SERVICE BULLETIN

CHECKING OR REPLACEMENT

OF FUEL PUMP PART NO. 892230/892235

SB-912-050

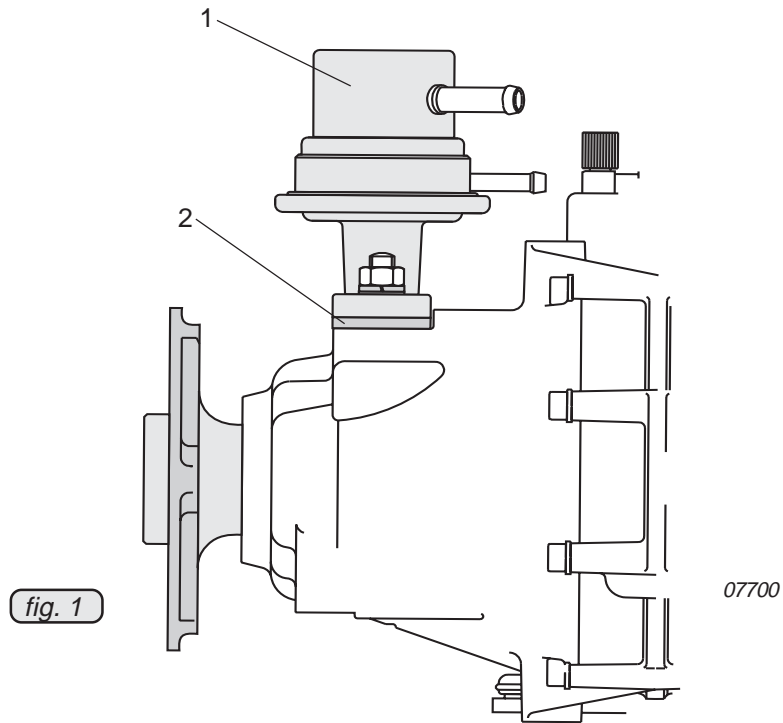
Geometry changes of the gasket can result in limited cases in subsidence and leakage. Therefore gasket (2) must be replaced by new part for all engines affected (See Fig 1).

- Remove fuel pump (1).
- Gasket (2) replaced by new part.
- Install fuel pump. Tightening torque 15 Nm (133 in.lb).
- Install fuel line.
- Restore aircraft to original operating configuration.
- Connect negative terminal of aircraft battery.
